Service Bulletin

Bulletin No.: 24-NA-101

Subject: 60/40 Seat Position Gap

Brand:	Model:	Model Year:		VIN:		Engine:	Transmission:
		from	to	from	to		
Cadillac	XT5	2022	2024

6664346

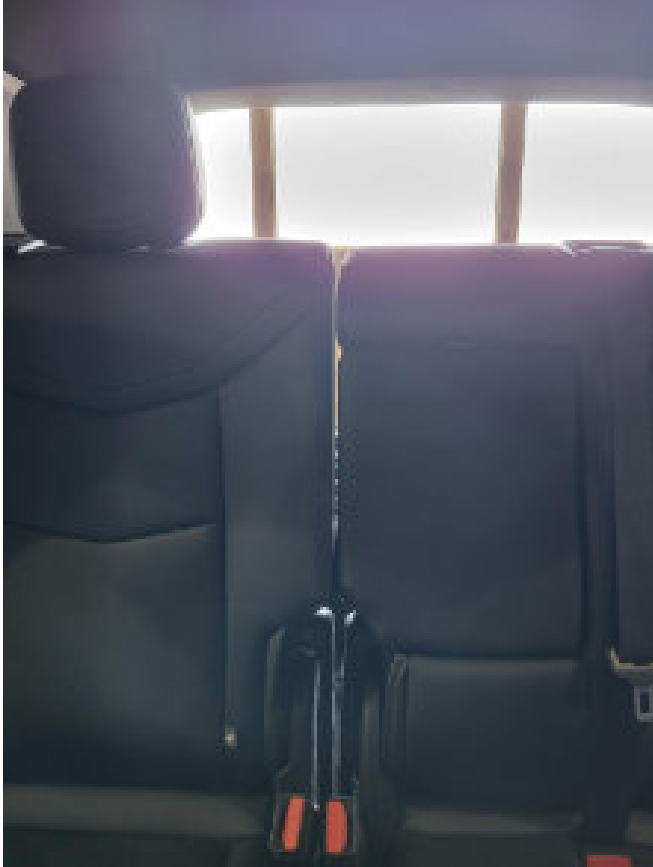
4. At the 60% seat, access the rear left hand leg and remove the bolt. Refer to *Rear Seat Removal and Installation (60%)*. Then, add steel washers underneath the leg with a new, longer bolt, seal with loctite or similar adhesive and re-secure the seat..

Example image above used a 1.5mm steel washer.

Note: Use steel washers, they must be the same diameter as the track spacer and the shape of the bottom side of the track. Use 1mm thick steel washers with increments up to 4mm max thickness can be used to adjust the seats.
